Work Order ID 119107

Item Name: Aft Crosstube - High

WORK ORDER NON-CONFORMANCE / UPDATE

DRAWING NO. REV. D
D212-664-241 SHEET 1 OF 4
TITLE SCALE
CROSSTUBE ASS'Y (205/212 HI AFT) NTS

D212-664-241/-241B
ASSEMBLY DETAIL

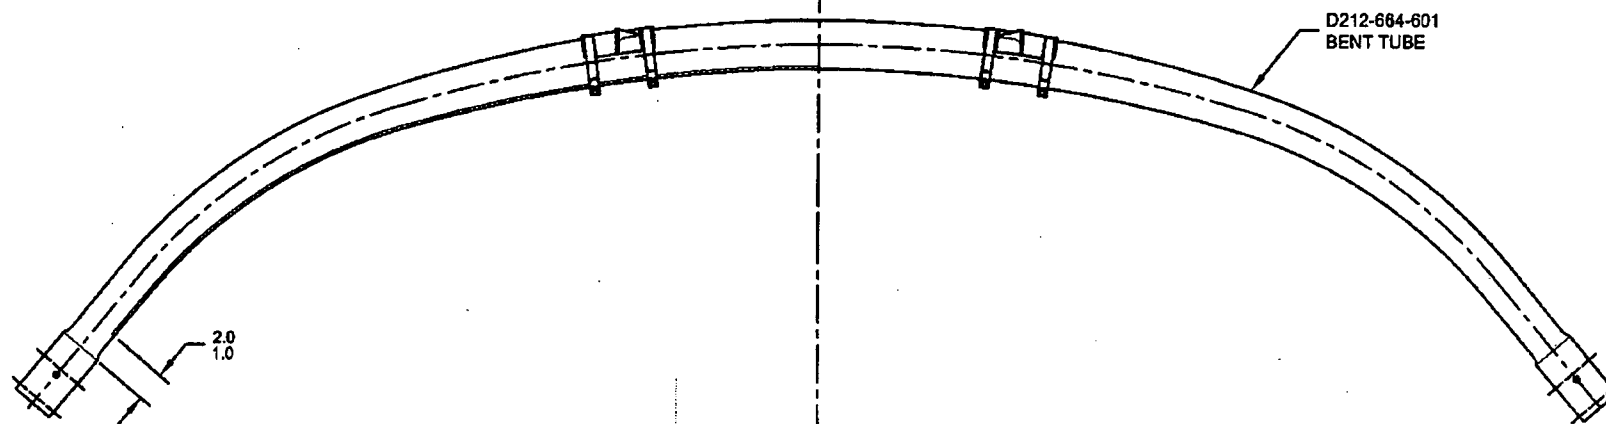
PURPOSE:

ADD AN INSPECTION WINDOW TO UNDERSIDE OF CROSSTUBE.

NOTES 2 OF SHEET 1 IS AMENDED AS FOLLOWS:

- 2) FINISH: CHEMICAL CONVERSION COAT PER DART QSI 005 4.1
PRIME INSIDE AND OUTSIDE PER DART QSI 005 4.2
MASK UNDERSIDE OF CROSSTUBE AS SHOWN (HATCHED AREA) AND
PAINT OUTSIDE PER DART QSI 005 4.2
REMOVE MASKING AND APPLY CLEAR COAT

MASK AREA PRIOR TO PAINTING,
REMOVE MASKING AFTER PAINT
AND APPLY CLEAR COAT

FIGURE 1: SUPPORT INSTALLATION

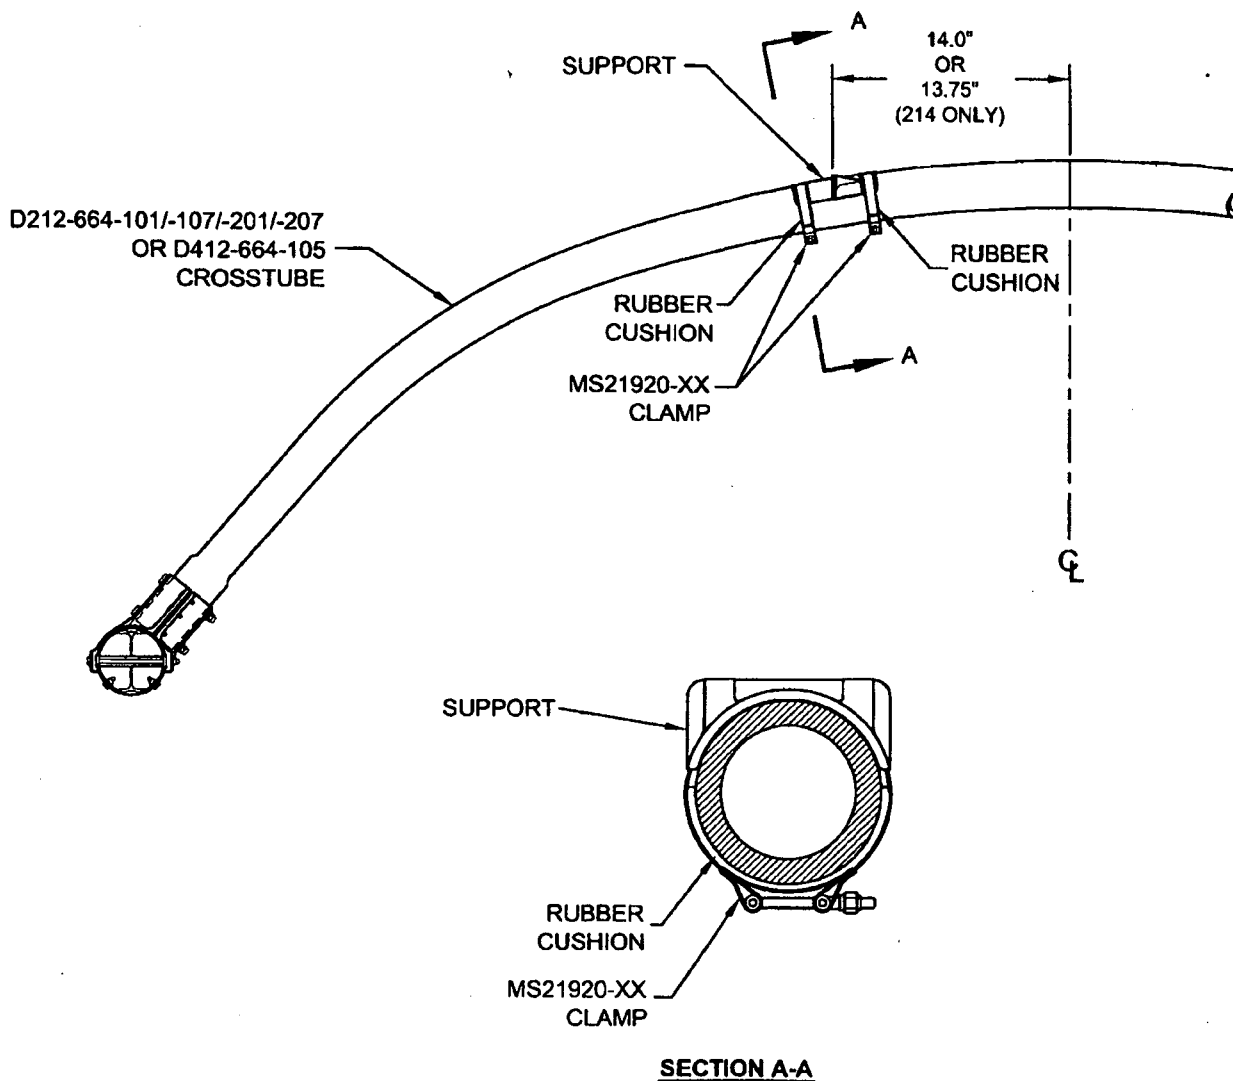
For the crosstubes listed above, section 32.4 of ICA-D212-664 is amended as follows. Use Figure 1 of this service instruction and Figures 32-2 to 32-9 of ICA-D212-664 for further reference. For crosstubes of an earlier change number, it is recommended that if the supports are removed, the supports should be reinstalled using the procedure listed below.

- 32.4.1 Locate the area on the crosstube for installation of support (see Figure 1 of this service instruction). For D212-664-101/-107/-201/-207 and D412-664-105 crosstubes, the outward face of the support tabs should be 14.0" (355mm) from the crosstube center for 204/205/210/412/UH-1 aircraft. For installation on 214B/B-1 aircraft, the outward face of the support tabs should be 13.75" (349mm). Ensure paint finish of crosstube is intact; touch up as required per Chapter 5 (5.3.9) of ICA-D212-664.

- 32.4.2 If present, remove any paint/primer on bottom of supports. Abrade mating surfaces of support and crosstube with 400-grit sandpaper. Saturate a clean cloth with MEK or 4105S Wash'n'Wipe Degreaser or equivalent and wipe until there is no residue.

- 32.4.5 Apply a 0.04" to 0.07" thick layer of Proseal 890 Class B or AMS-S-8802 Class B sealant underneath applicable support and install support as shown in Figure 1 of this service instruction.

- 32.4.6 Install the clamps opposite to crosstube support as shown in section A-A of Figure 1. Install rubber cushions underneath each clamp around the bottom circumference of the crosstube up to the crosstube centerline. Torque clamps 80-100 in-lb (9.0-11.3 Nm). It is acceptable to use smaller or larger sized MS21920-XX clamps than those listed in ICA-D212-664, ensure that after torquing the clamps per this instruction, the nuts are in safety but not bottomed out

CRUSHING OF D212-664-201

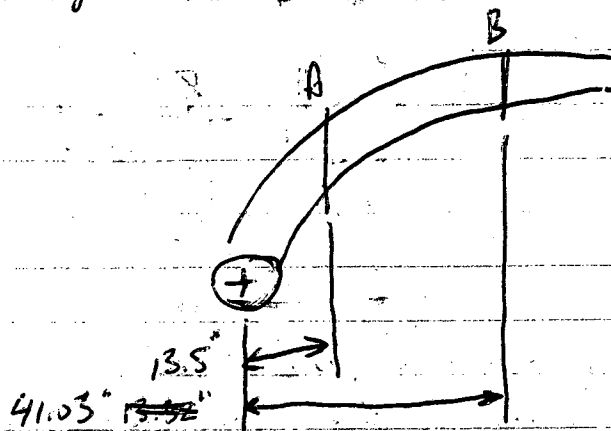
Acceptability of 8% CRUSHING

Point A: $OD1 = 2.548 \text{ in}$ $OD2 = 2.992 \text{ in}$
 $CRUSHING = (2.992 - 2.548) / (2.992 + 2.548) = 8\%$
 $I = 1.476 \text{ in}^4$
